Division Street & Orcutt Place Storm Sewer and Pavement Rehabilitation

ADDENDUM NO. 1

SW DIVISION STREET (PARK ROW TO WASHINGTON) STREET/STORM PLAN AND PROFILE
 DIVISION STREET AND ORCUTT PLACE STORM SEWER AND PAVEMENT REHABILITATION
 LOCATED IN SECTIONS 32B & 32C, T2S, R1W, W.M. IN THE CITY OF SHERWOOD, WASHINGTON COUNTY, STATE OF OREGON

JOB NO. _____ SHEET NO. **5** OF **13**

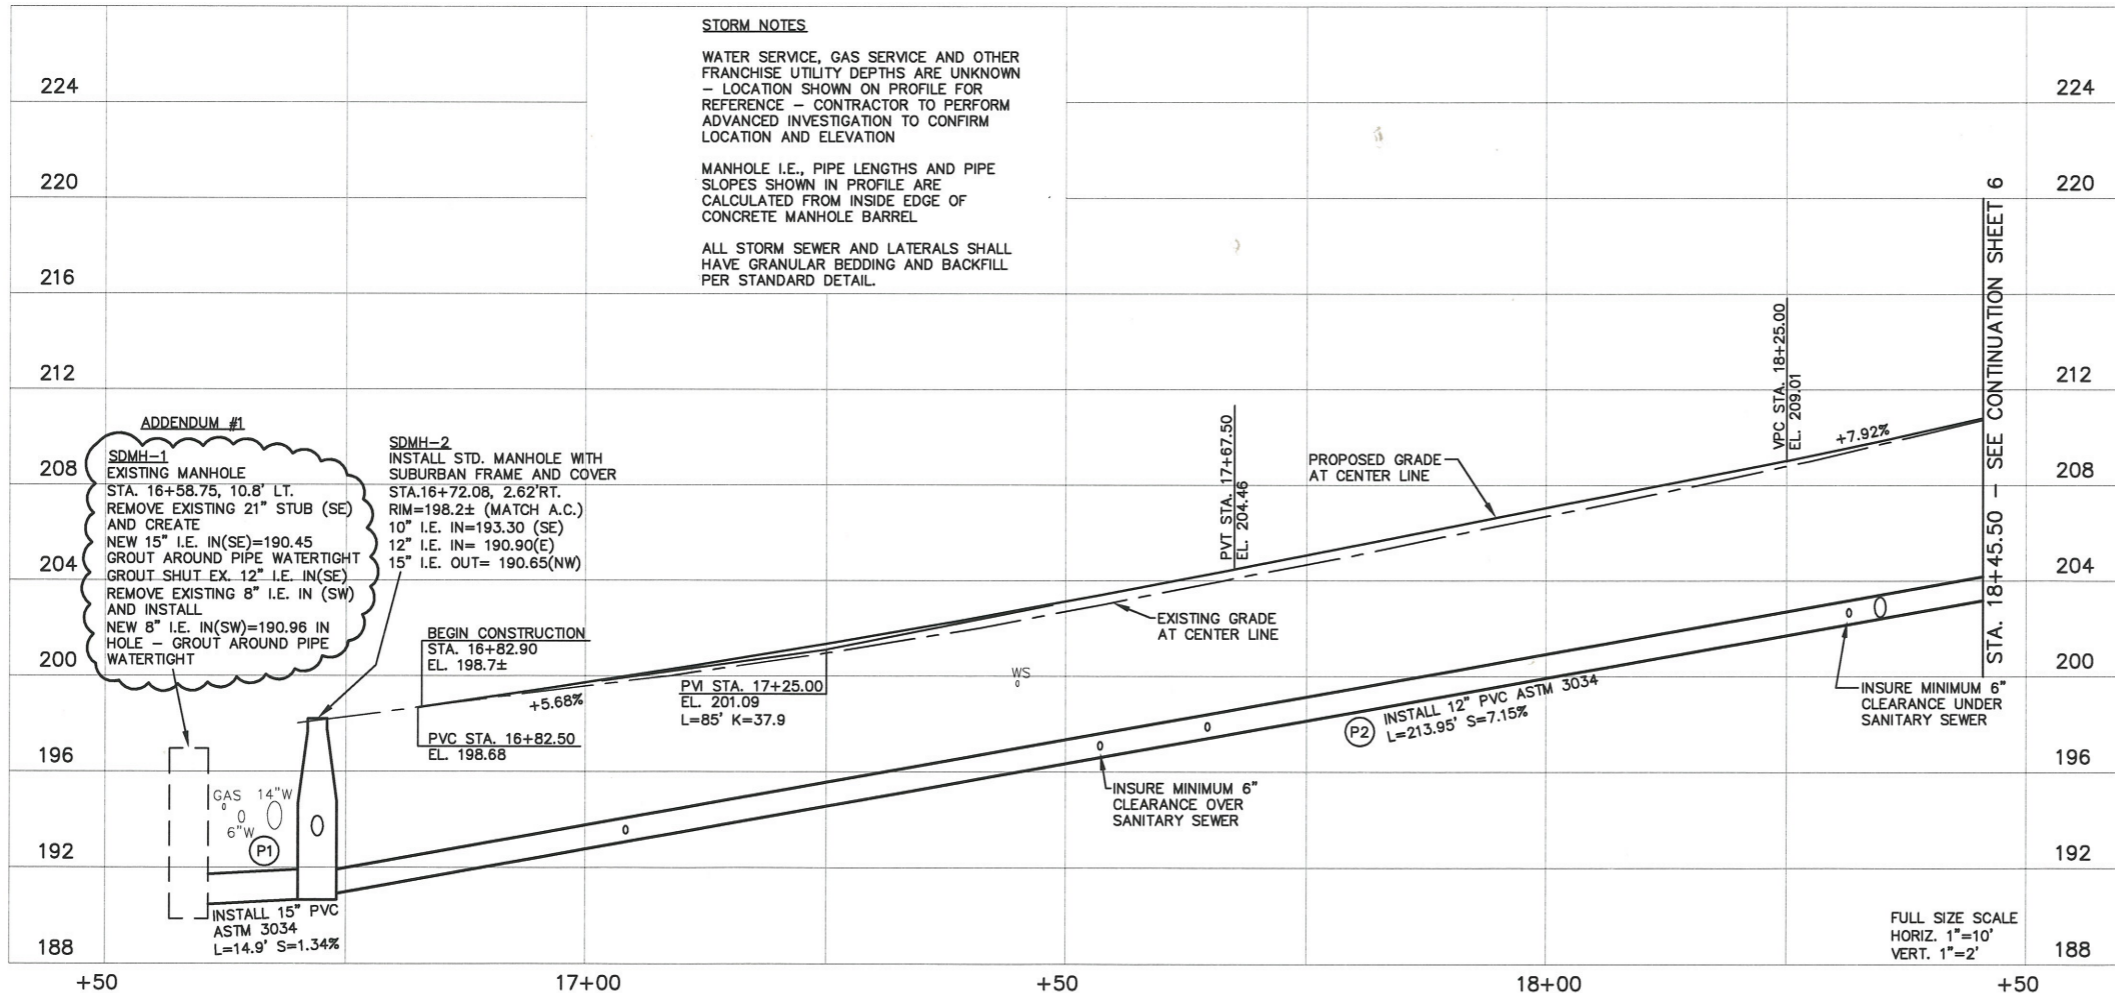
1. Sheet 5 of the Contract Drawings (Division Street – Park Row to Washington) was changed to add additional piping and remove existing piping. Revision clouding has been placed on the Contract Drawings to identify the changes (changed sheet attached).
2. Pages 1-3 (Division Street – Park Row to Washington Bid Schedule) of the Bid Schedule have been modified to account for the quantity change as a result of the change to the Contract Drawings (changed pages attached).
3. Section 00445.91 of the Special Provisions has been modified to add a pay item for "8-Inch, PVC, ASTM 3034, SDR 35 Pipe (Granular Backfill)" (changed page attached).

- (P5) INSTALL 15' OF 15" D.I., CL.50 PIPE AT ±23%
 - (P6) INSTALL 28.5' OF 8" PVC, ASTM 3034 PIPE AT 2.0%
- ADDENDUM #1**
 INSTALL NEW WYE AND ±5' OF 8" PVC PIPING, BENDS NECESSARY AND STRONG BACK FERRO OR APPROVED EQUIVALENT TO CONNECT TO EXISTING PIPE. INSTALL 8" CLEANOUT. ALL INCLUDED IN THE BID ITEM "CLEANOUT, 8-INCH".

INSTALL NEW WYE AND ±5' OF 8" PVC PIPING, BENDS NECESSARY AND STRONG BACK FERRO OR APPROVED EQUIVALENT TO CONNECT TO EXISTING PIPE. INSTALL 8" CLEANOUT. ALL INCLUDED IN THE BID ITEM "CLEANOUT, 8-INCH".
